APPLICATION NO.	FILING DATE	FIRST NAMED INVENTOR	ATTORNEY DOCKET NO.	CONFIRMATION NO.
10/582,673	06/22/2006	Toshiyuki Inagaki	128357	5009

Office Action Summary	Application No. 10/582,673	Applicant(s) INAGAKI, TOSHIYUKI	
	Examiner ASHLEY KWON	Art Unit 1795

DETAILED ACTION

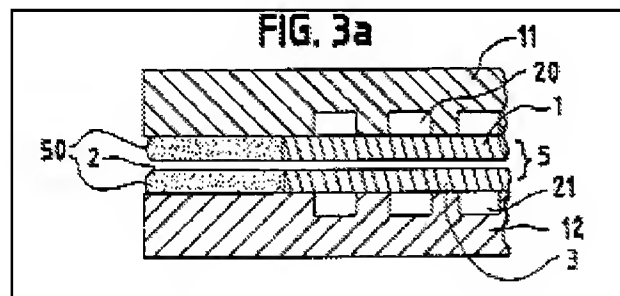
Regarding claim 27, Schmid discloses a fuel cell stack (see fig. 1) comprising: a pair of separators (11, 12); an MEA (5) in which an electrolyte membrane (2), a catalyst layer, and a diffusion layer (electrode layers 1, and 3) are laminated (see col. 1, lines 21-33), and which is provided between the pair of the separators; and an adhesive layer (50) provided between the pair of the separators, which contacts at least an end of the electrolyte membrane, an end of the catalyst layer and an end of the diffusion layer (see fig. 3a). Schmid discloses two possible MEA configurations, one where the membrane extends beyond the electrodes, and another where the membrane is coextensive with the electrodes (see col. 6 line 61 – col. 7, line 5). In both configurations the adhesive layer would contact at least an end of the membrane, catalyst layer, and diffusion layer.

Schmid fails to explicitly disclose a fuel cell stack wherein the adhesive layer has a Young's modulus of at most within the range of 30 MPa to 100 MPa.

However Schmid does disclose that PUR, such as, for example Araldite 2018 is suitable for use in his invention (see col. 5, lines 43-44). Araldite 2018 has a tensile modulus (also known as Young's Modulus) of 16 MPa (see Araldite pg 3/5). It has been held that when the difference between a claimed invention and the prior art is the range or value of a particular variable, then a prima facie rejection is properly established

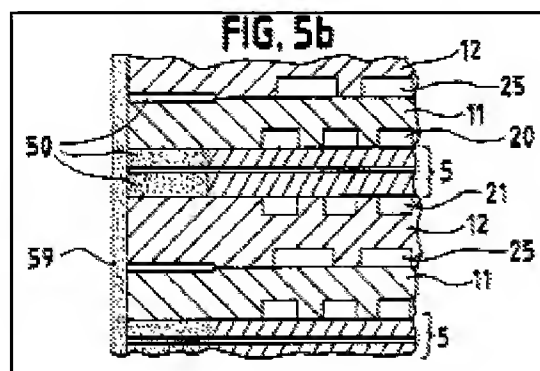
Regarding claim 35, Schmid discloses the fuel cell stack according to claim 27, wherein multiple cells, each of which is formed by interposing the MEA between the pair of separators, are linearly arranged in a cell stacking direction, and the fuel cell stack further comprises an adhesive layer sandwiched between two cells adjacent to each other (*Schmid*: see col. 4, lines 32-34, see fig. 5b).

Regarding claim 36, Schmid discloses the fuel cell stack according to claim 27, wherein multiple cells, each of which is formed by interposing the MEA between the pair of separators, are linearly arranged in a cell stacking direction, and a bead gasket is provided as a seal between two of the multiple cells, which are adjacent to each other, and a separator of the two of the multiple cells which contacts the bead gasket has a greater planar rigidity than a separator of another cells which does not contact the bead gasket. Schmid discloses that some of all the cells in the stack may be adhesively

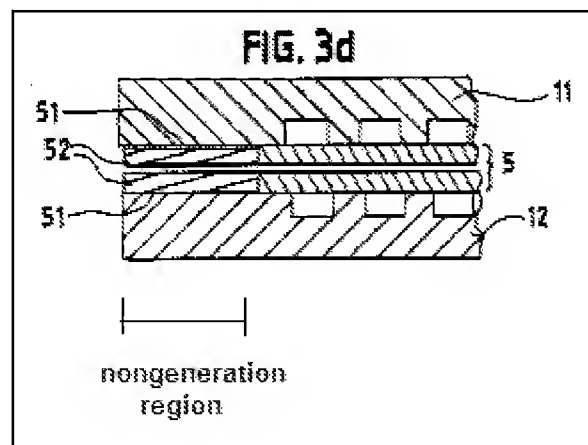
Regarding claim 32, Schmid discloses the fuel cell stack according to claim 27, wherein a rigid spacer (51) is provided in the adhesive layer (52) (*Schmid*: see fig. 3d). Barring specification as to the composition of the rigid spacer, an adhesive film made of epoxy, a known hard substance, will be interpreted as meeting the claim (see col. 7, lines 62-63; col. 5, lines 35-40).

Regarding claim 33, Schmid discloses the fuel cell stack according to claim 32, wherein the rigid spacer (51) is provided in the adhesive layer (52) throughout a non-generation region (see annotated fig. 3d).
